Change Order

Edward Devotion School Project
Town of Brookline
333 Washington Street
Brookline, MA 02245

CHANGE ORDER NUMBER: 016

(Include, where applicable, any undisputed amount attributable to previously executed Construction Change Directives)
CR009 Fill Voids Under 1913 Building SOG \$5,865; CR089 PR #15R1 - Extended Slab at K-2 Wall Footing \$3,398; CR093
PR #73 - LGMF Back-up Wall in Large Gym \$20,542; CR117 PR #85 - Shadow Box at CW28 and Added Gyp Soffit \$2,388;
CR131 Replacement of Bird Screens at Cupola per HMFH Field Report \$966; CR136 RFI #368 - Added Wall in MDF 109
\$2,434

Sheet Title  
Section Sheet

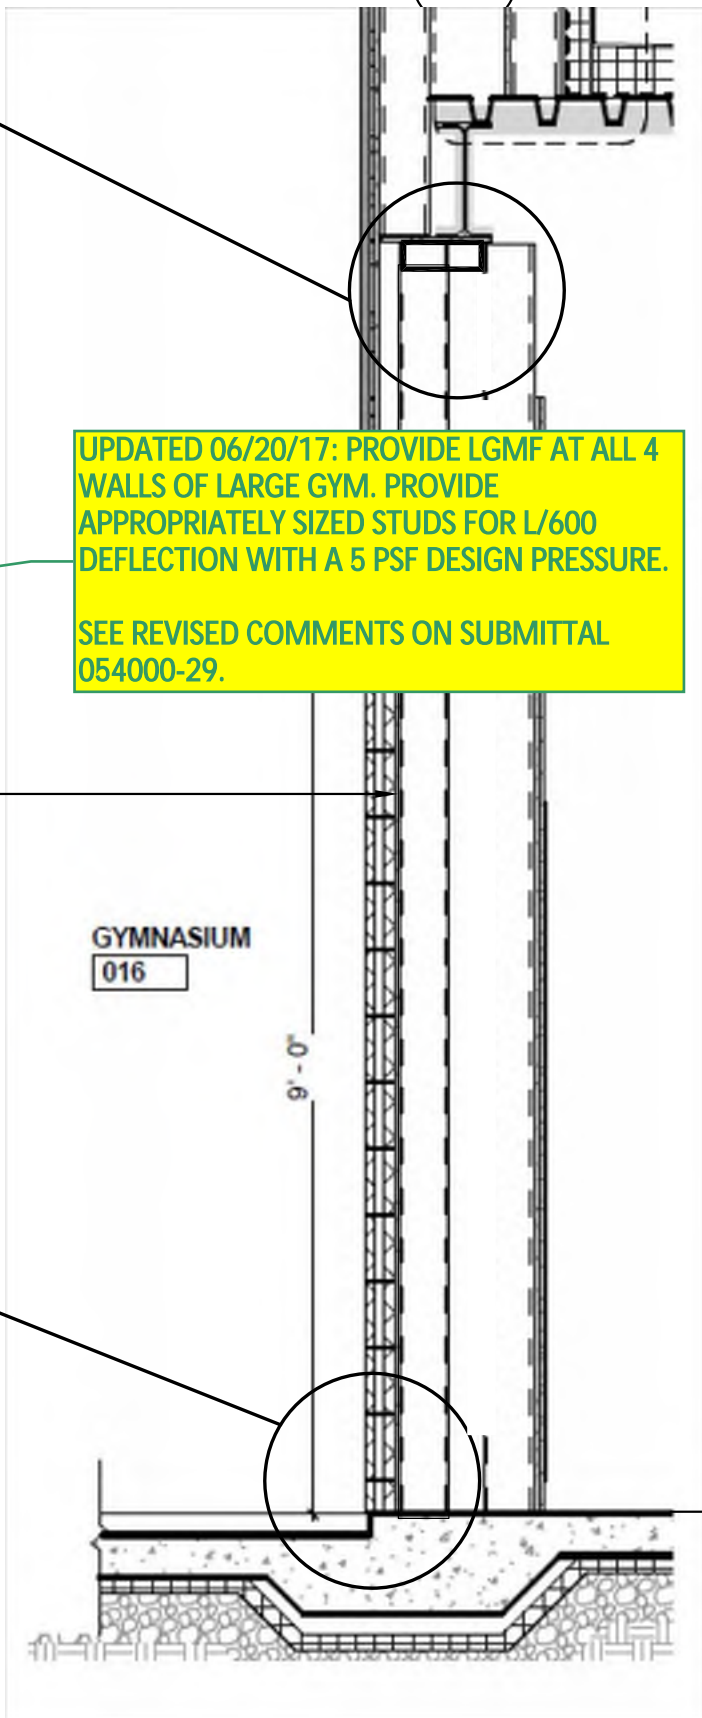
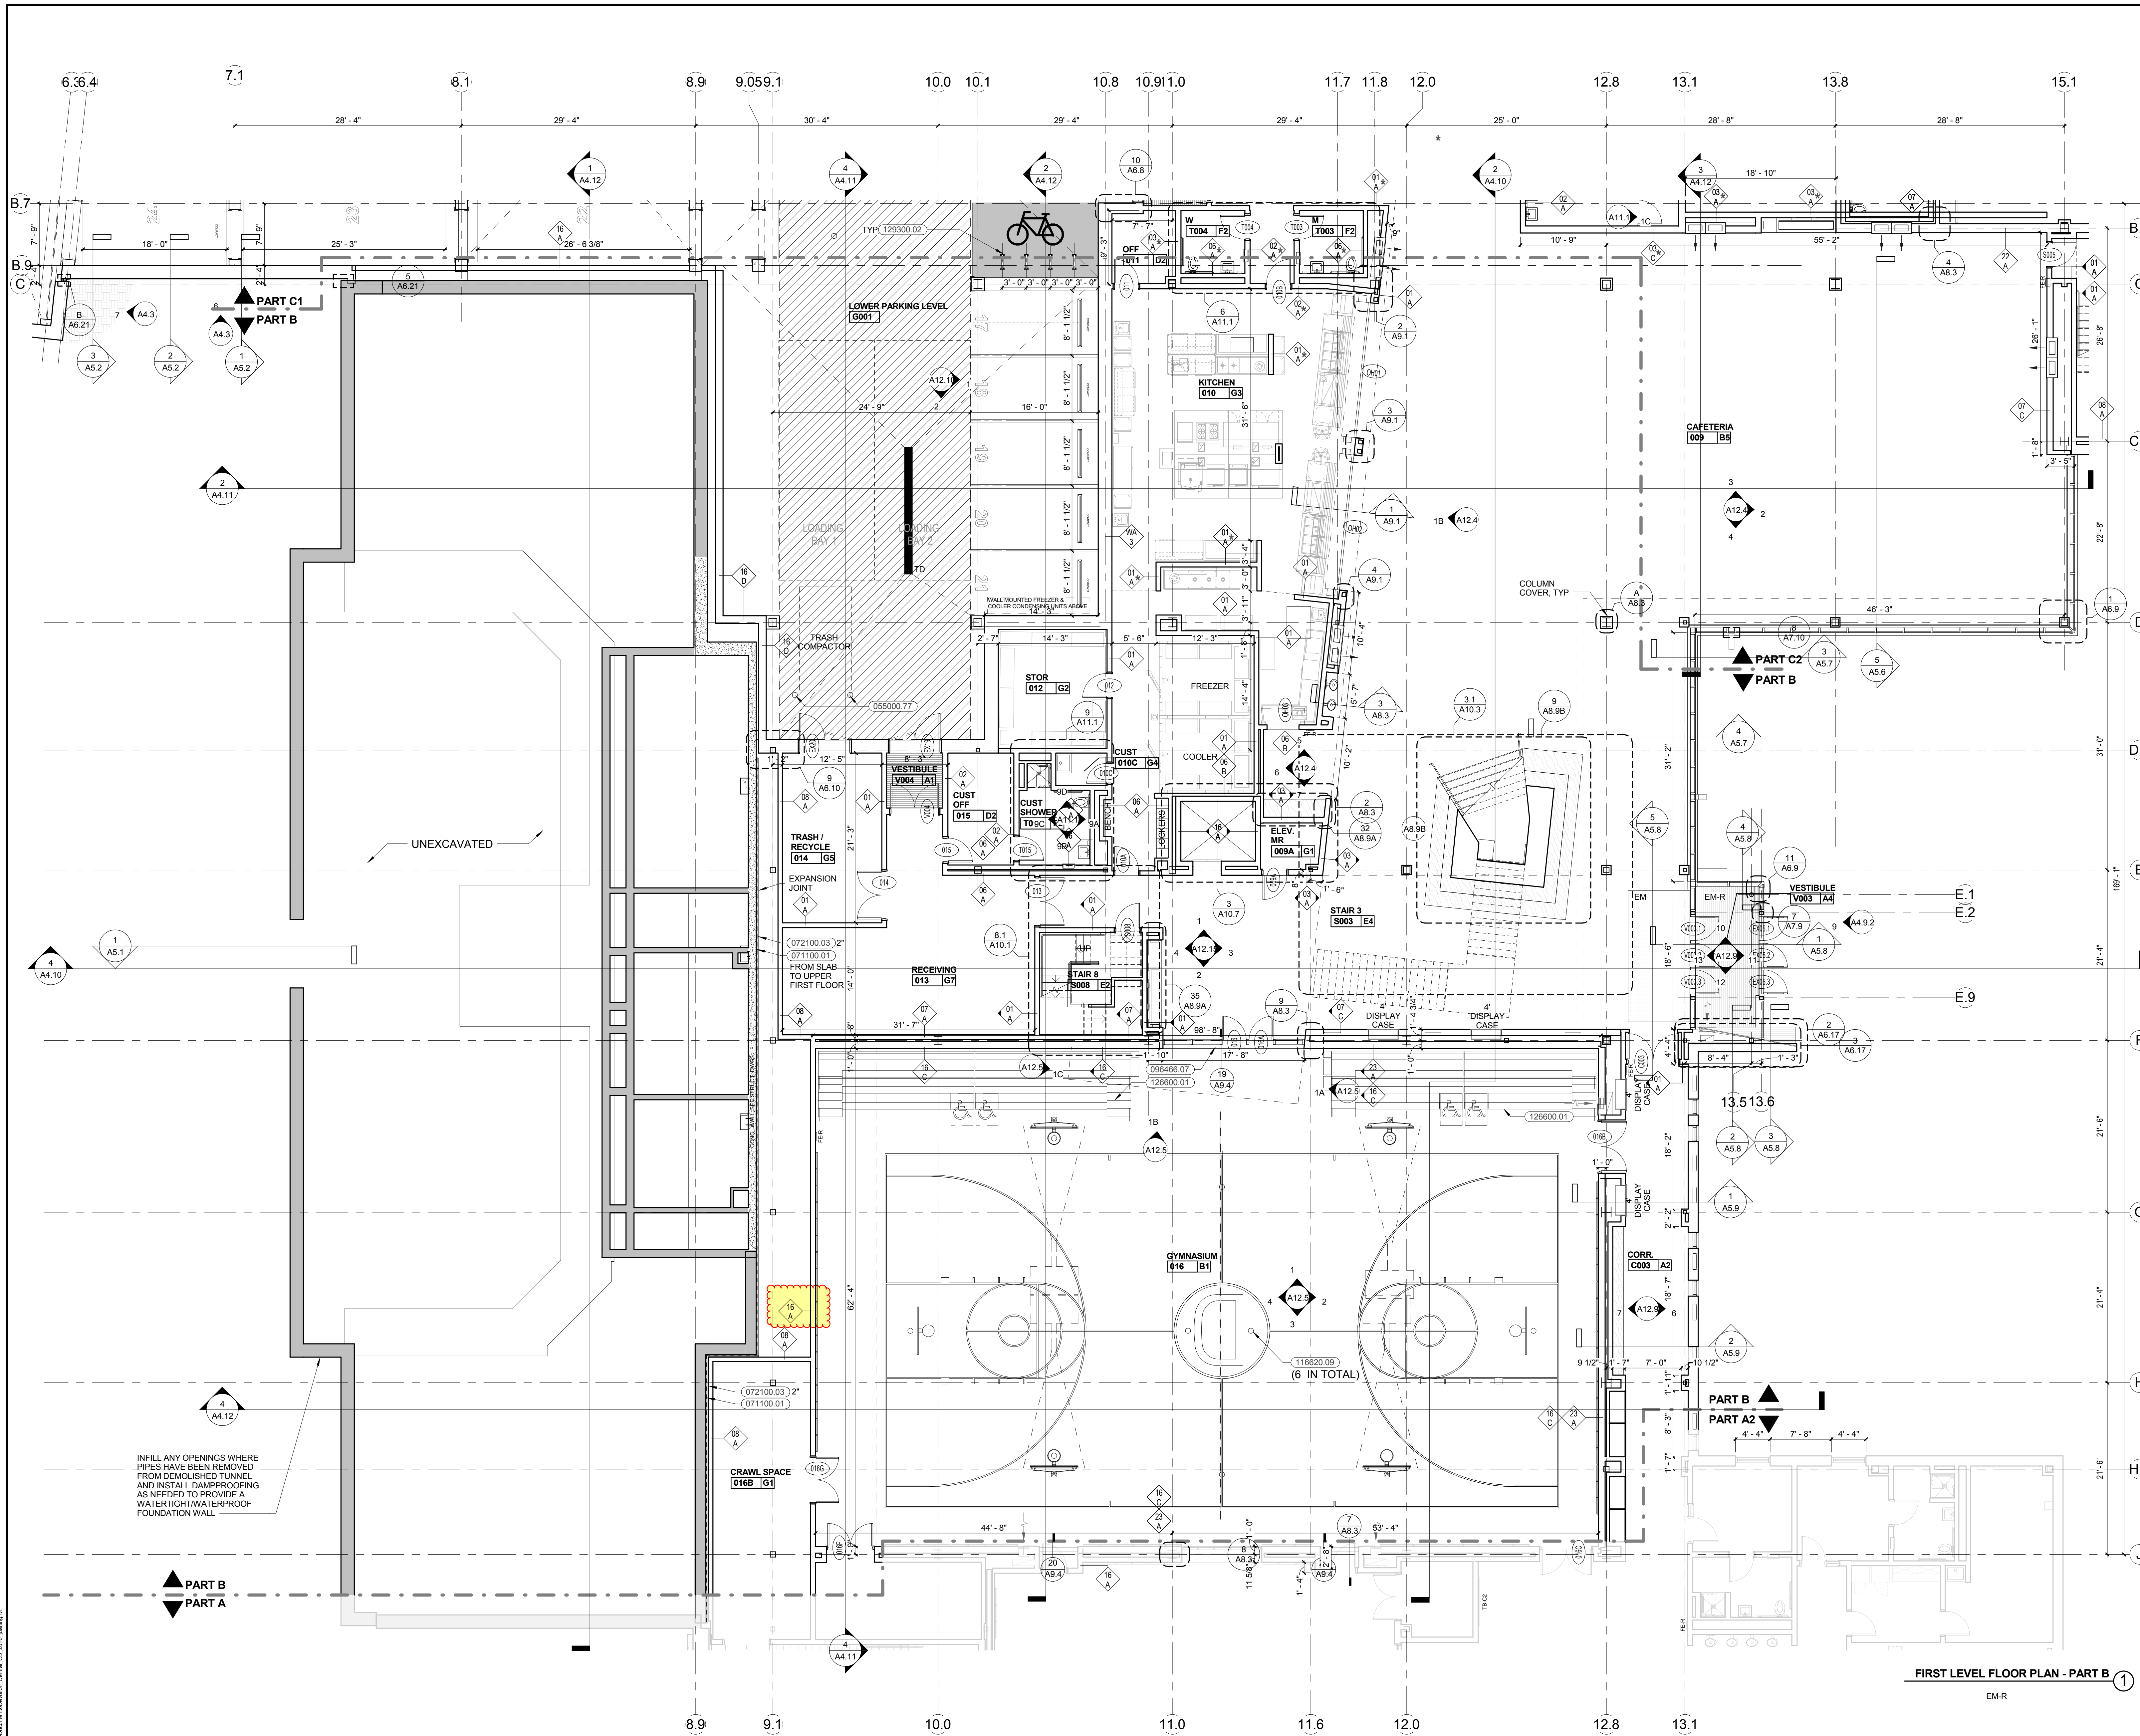
It is noted in the comments for Submittal #054000-29.0 (Interior Cold Formed Metal Framing Shop Drawings - Gym) that LGMF back-up is to be provided at all (4) walls of the large gym. Drawing A2.1b calls out wall type 16A for the west wall of the large gym, which is a 7-5/8" CMU wall. Due to the height of this wall, it will be difficult to meet deflection criteria with LGMF. Please clarify whether this wall in the large gym should be type 16A as shown on drawing A2.1b or type 23A similar to the other walls in the large gym and as marked up in the submittal.

**UPDATED 06/20/17: PROVIDE LGMF AT ALL 4 WALLS OF LARGE GYM. LGMF AT THE WEST WALL TO EXTEND TO THE UNDERSIDE OF THE DECK. PROVIDE APPROPRIATELY SIZED STUDS FOR L/600 DEFLECTION WITH A 5 PSF DESIGN PRESSURE. THESE REQUIREMENTS ARE OUTLINED IN SPECIFICATION SECTION 092900.**

provide mid-height wall bridging both side of stud flanges, typical with solid blocking along strap every 10'

Brookline, MA  
 Revision to A3.1c  
 RCP at Stair 5  
 Added Gyp Soffit

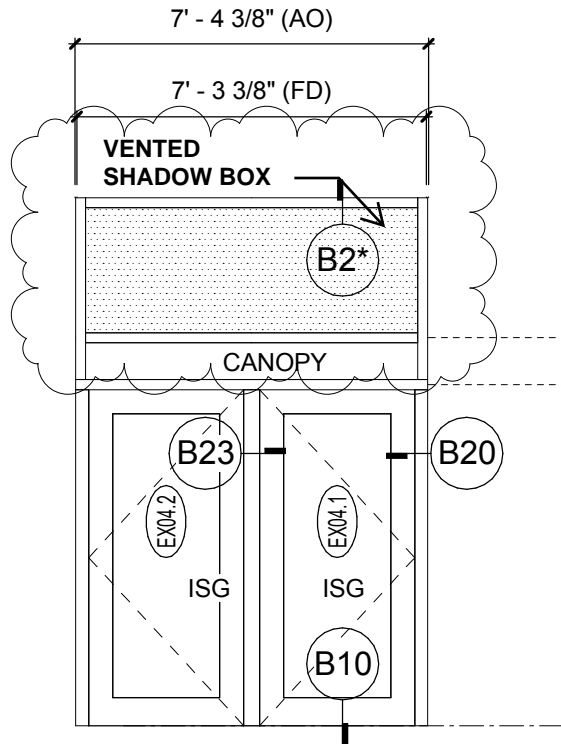
<b>Proposal Request Description:</b>
Please submit an itemized proposal for changes in the Contract Sum and Contract Time for proposed modifications to the Contract Documents described herein.
<b>THIS IS NOT A CHANGE ORDER, A CONSTRUCTION CHANGE DIRECTIVE OR A DIRECTION TO PROCEED WITH THE WORK DESCRIBED IN THE PROPOSED MODIFICATIONS.</b>
<p>Curtain wall:</p> <ul style="list-style-type: none"> <li>- Add Shadow Box at upper light on CW 28. SEE SKA-377</li> <li>Ceiling Modifications SEE SKA-376</li> <li>- Provide Gyp soffit and fascia</li> </ul>
